Project name: Case 24-04 & 24-05 Hudson Commercial Minor Subdivision and Site Plan

Review Number: 1

HUDSON COMMERICAL
FINAL SITE PLAN

2 of 2

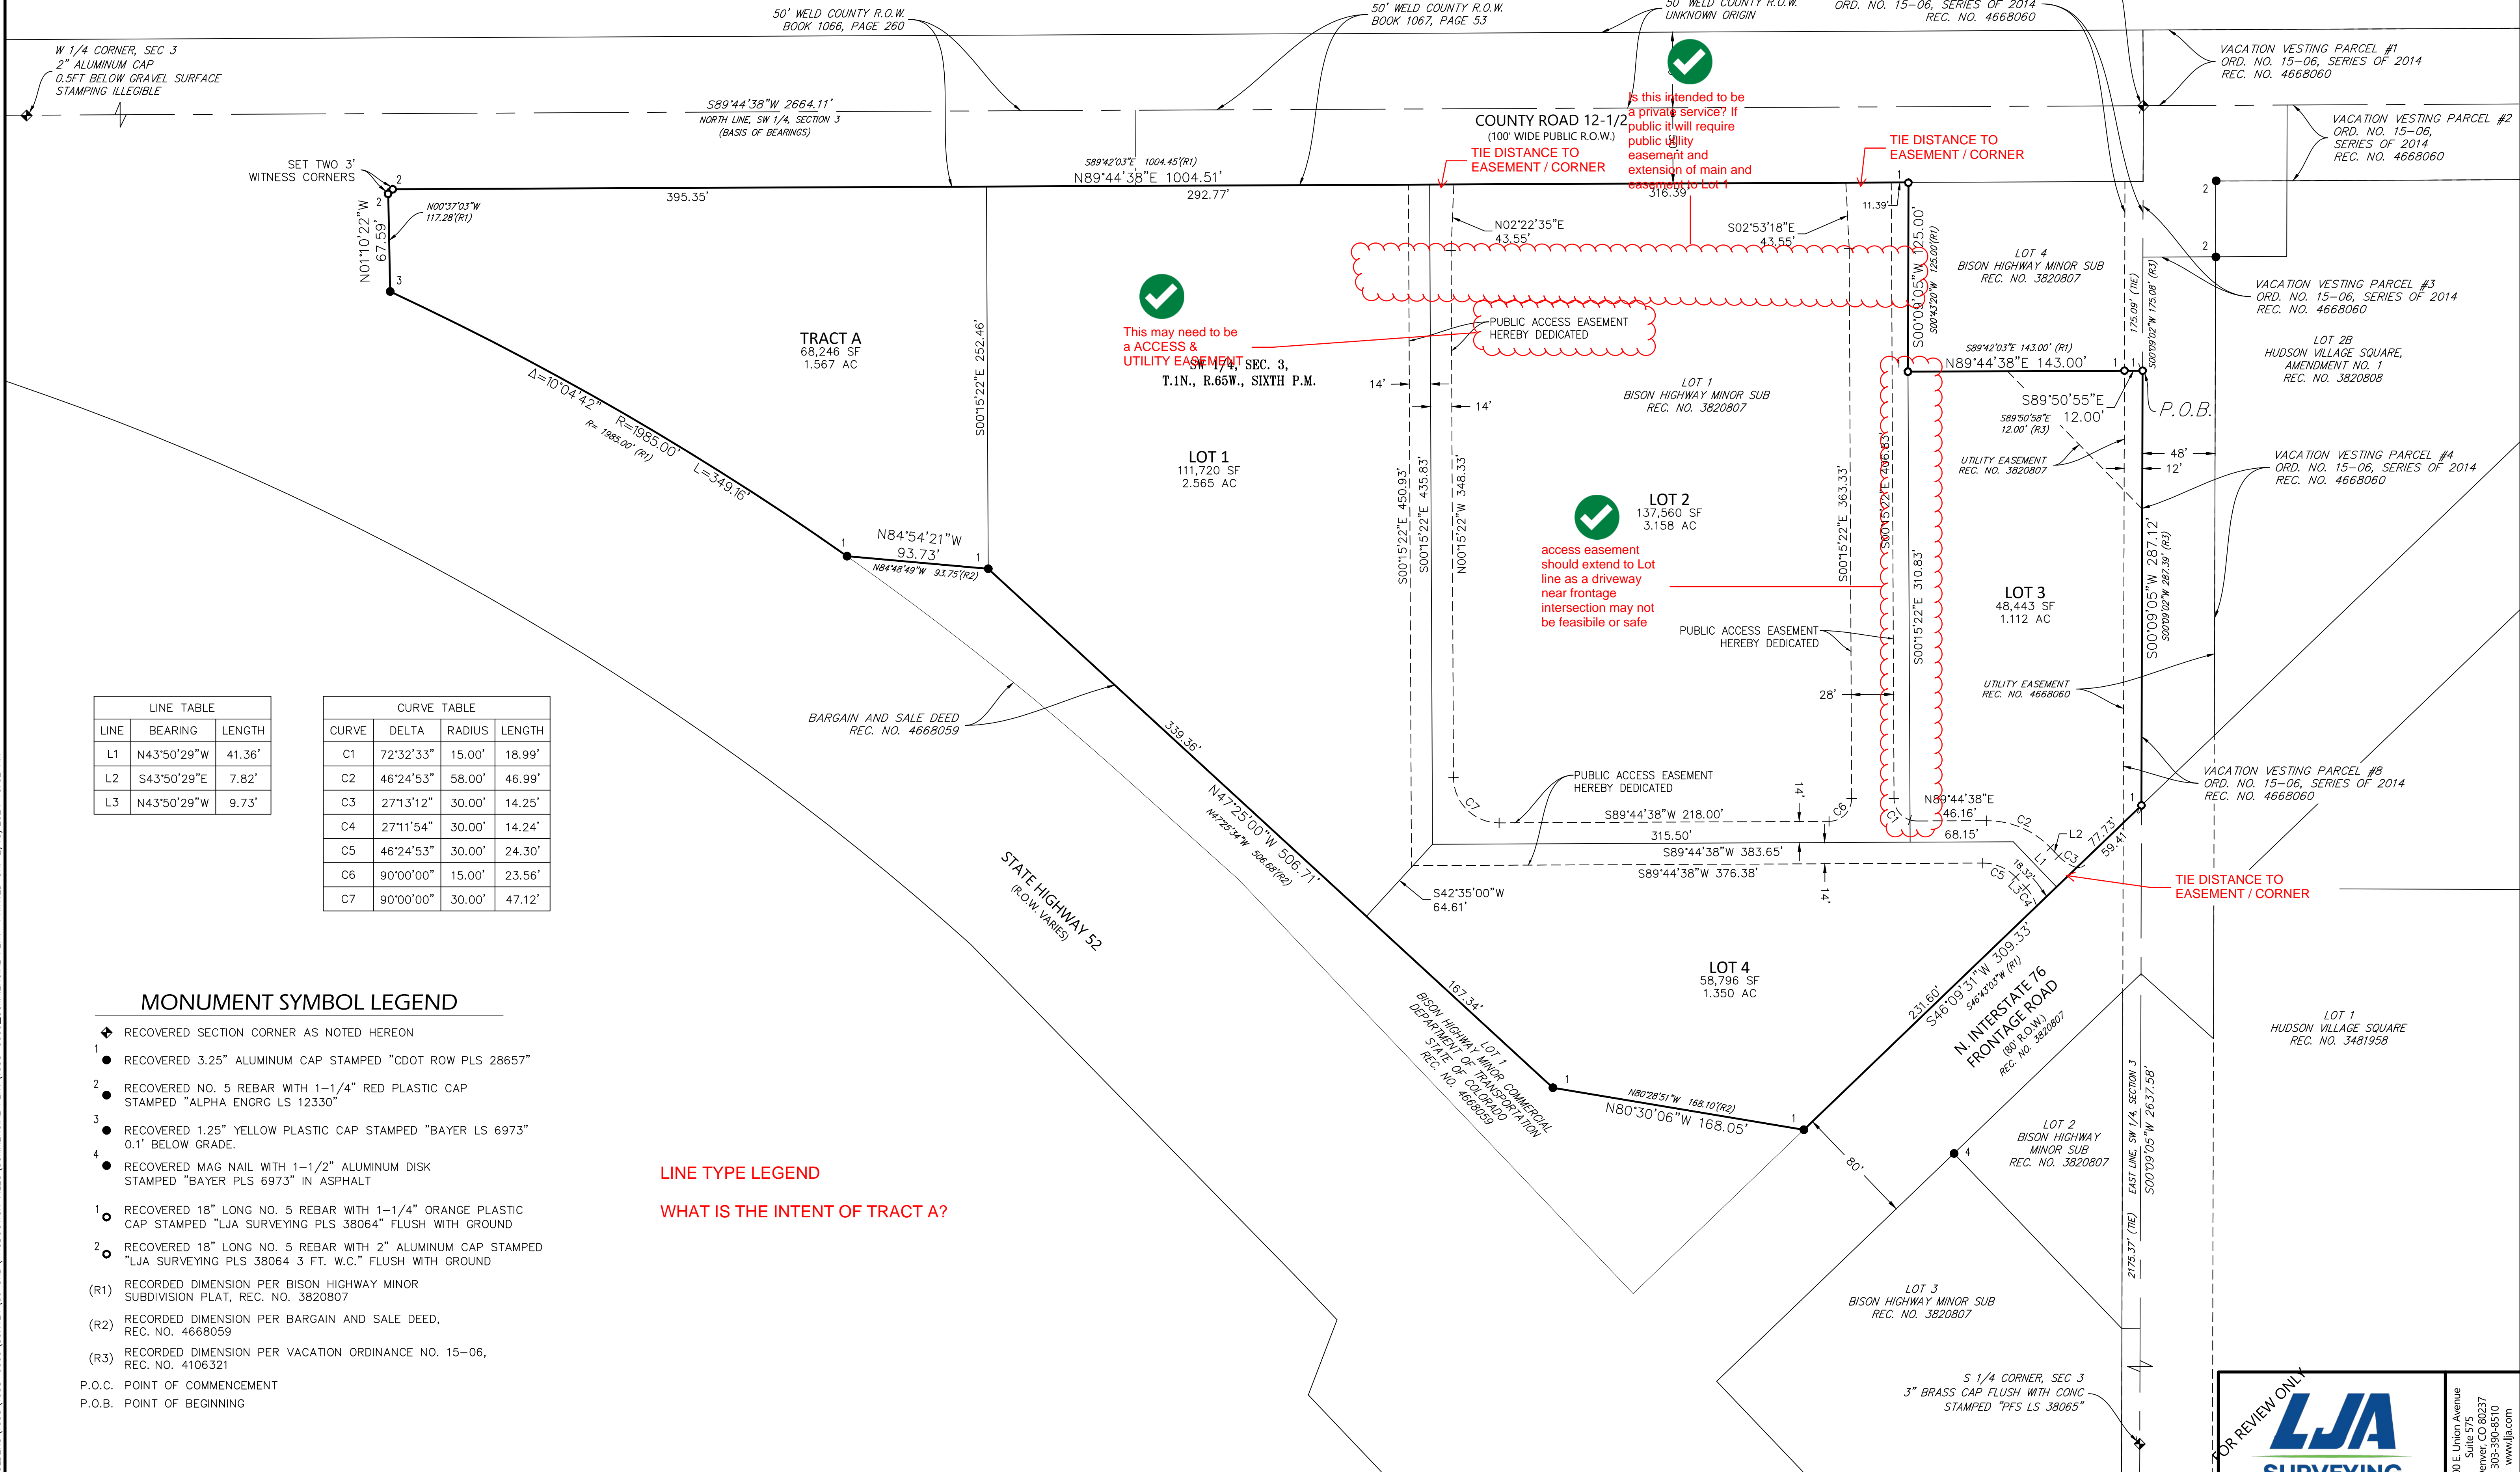
WHAT IS THE INTENT OF TRACT A?

Proj. Name:	Hudson Commerical
Location:	Hudson, CO
Plan Set:	Final Site Plan
Sheet Name:	Cover Sheet

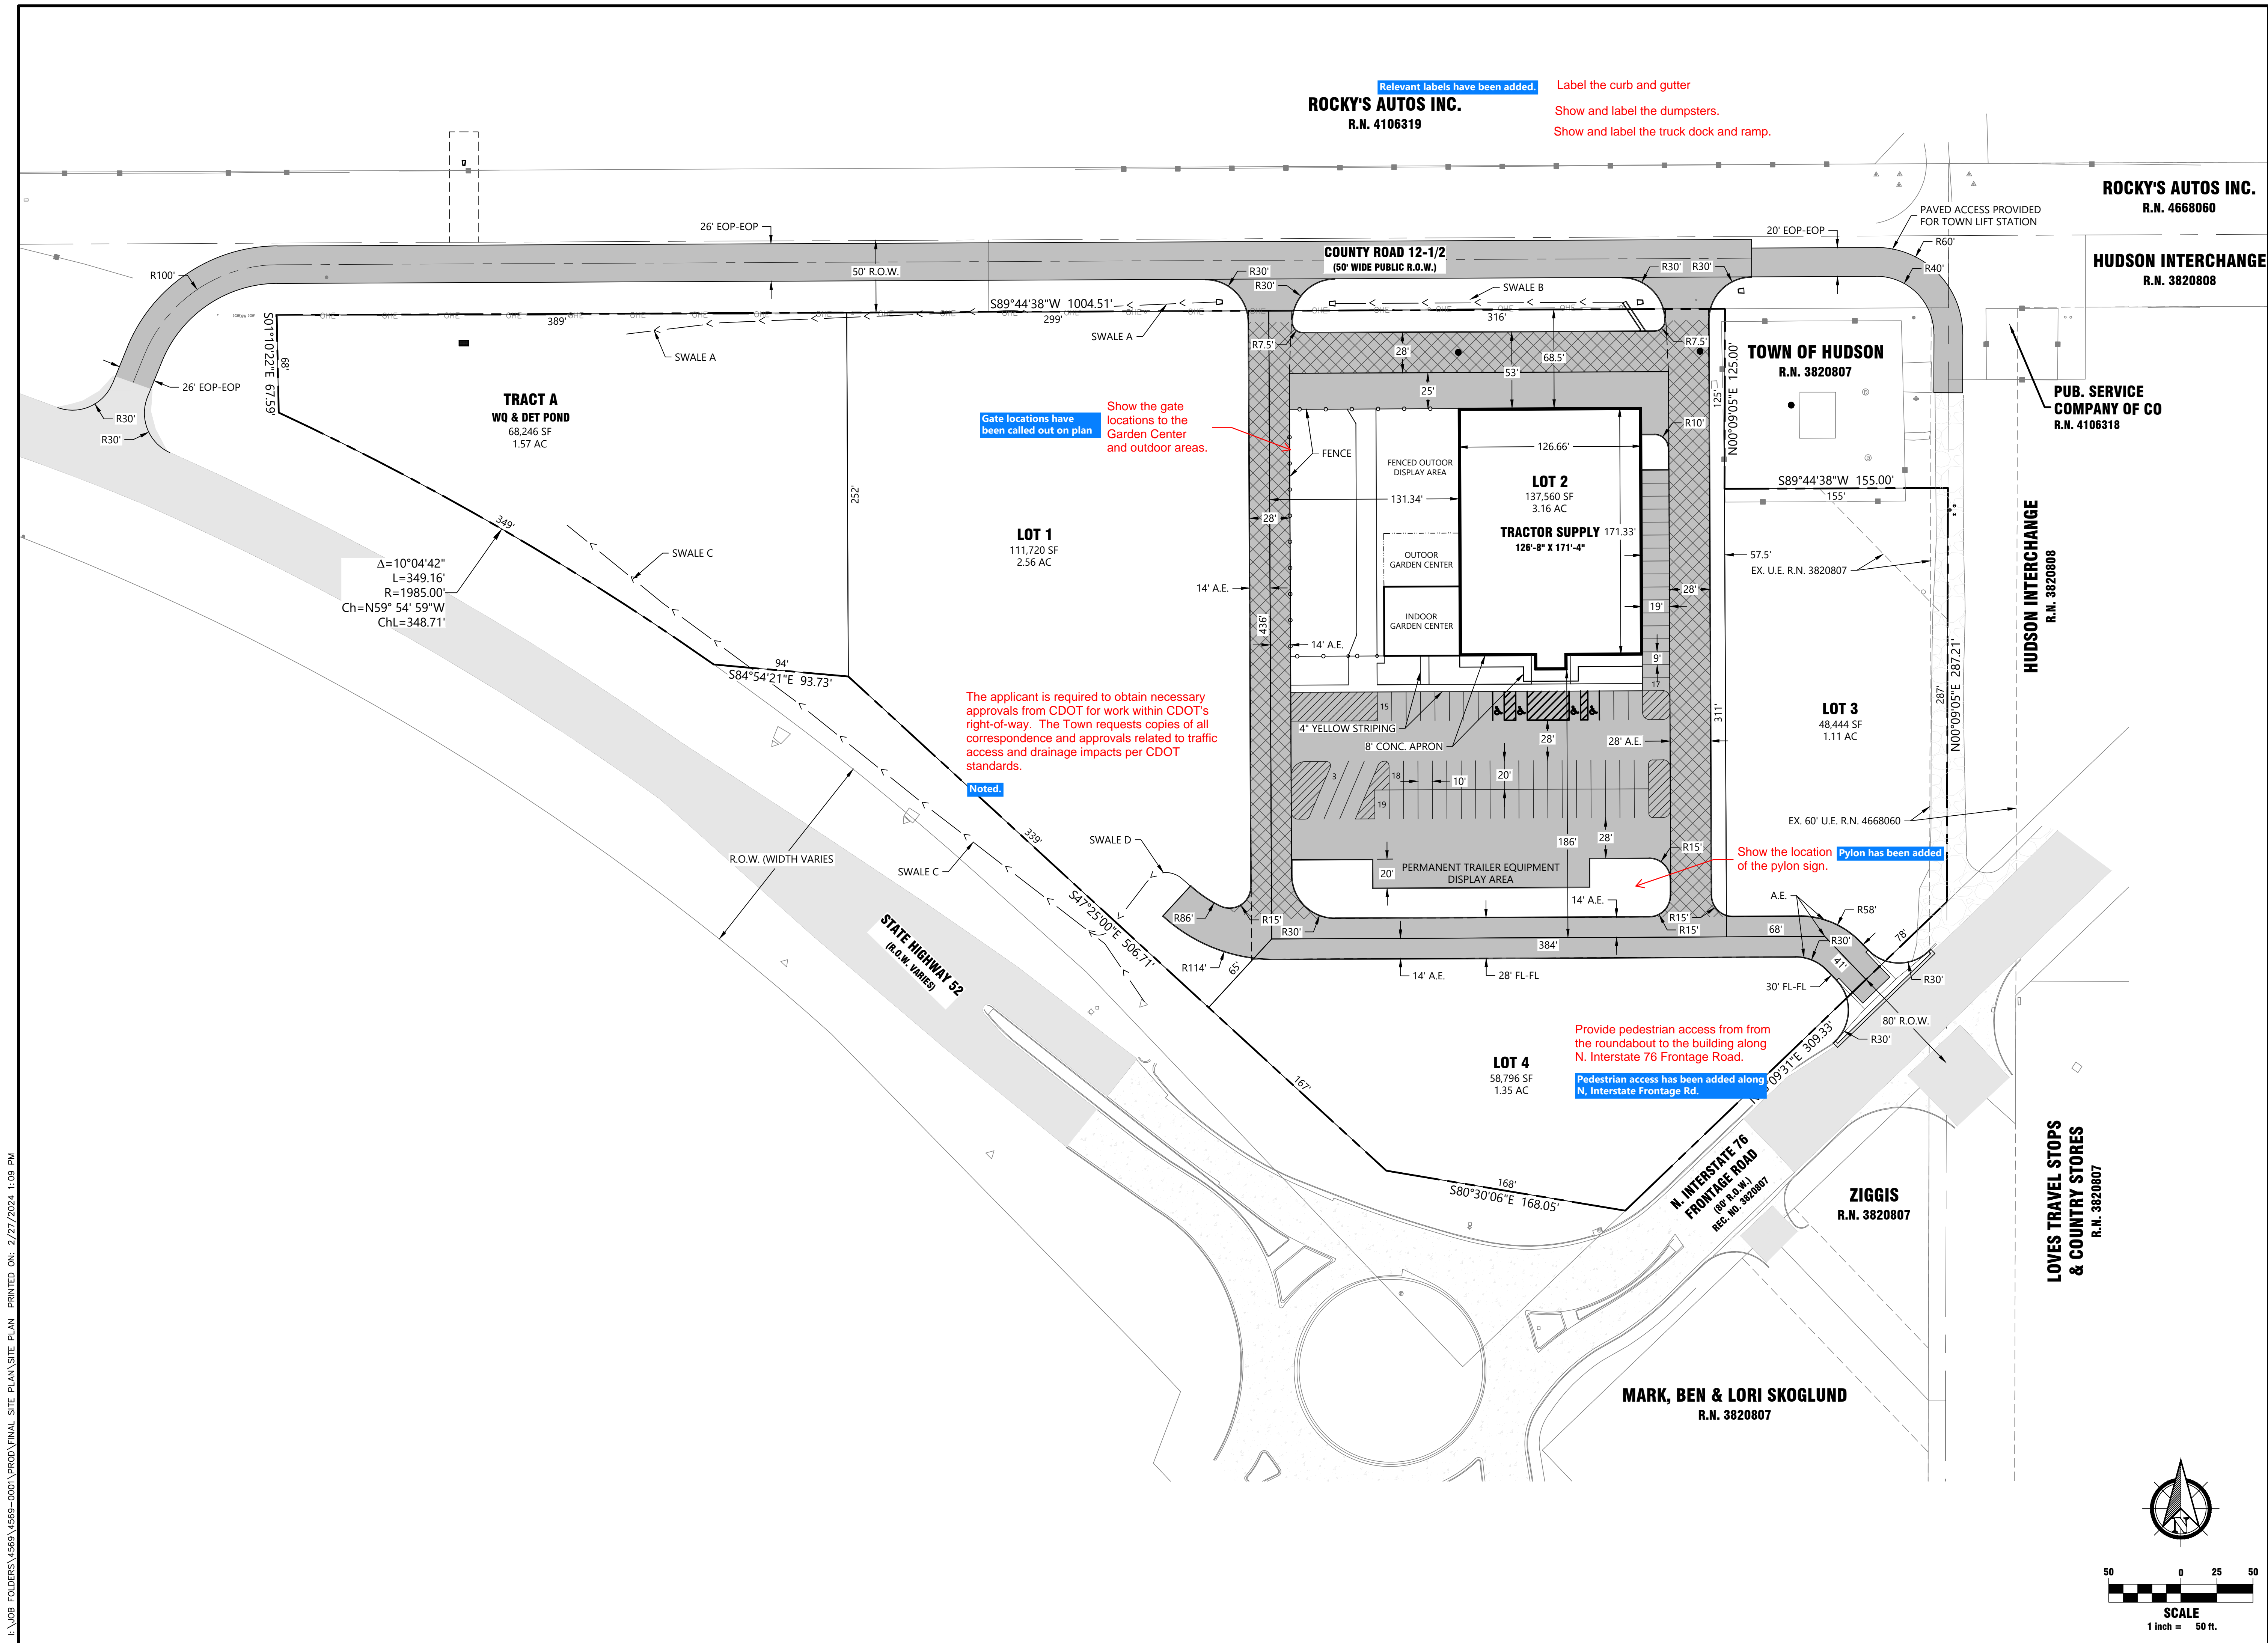
Provide a sheet index.

Provide an existing conditions drawing.

Provide required site plan submittal information from Section 16-77-c of the Town of Hudson Municipal Code. Missing information (but not limited to) include:

- Gross and net acreage of proposed uses
- Number of lots and tracts
- Area of development
- Square footage of building
- Floor area ratio
- Maximum and proposed building height per per zone district
- Number of required and provided parking stalls
- Number of handicap stalls
- Number of compact spaces (if applicable)
- Number of required and provided bicycle spaces
- Current and proposed zoning
- Lot setbacks per zone district
- Proposed area landscaping/open space

Include legal description and PLSS information as shown on the plat.

Provide a project contact list with contact name, address, and contact information for the following (at minimum):

Provide Town of Hudson approval blocks.

Provide a benchmark and basis of bearing. We prefer it's the same benchmark and basis of bearing the surveyor used for the plat.

Landscaping plans were not provided in the received materials.

Sheet index has been provided.

Existing conditions plan has been provided.

Information has been provided.

Legal description has been provided.

Project Contact List has been provided.

Town of Hudson Approval Blocks have been provided.

Benchmark has been provided.

Landscaping plans have been provided.
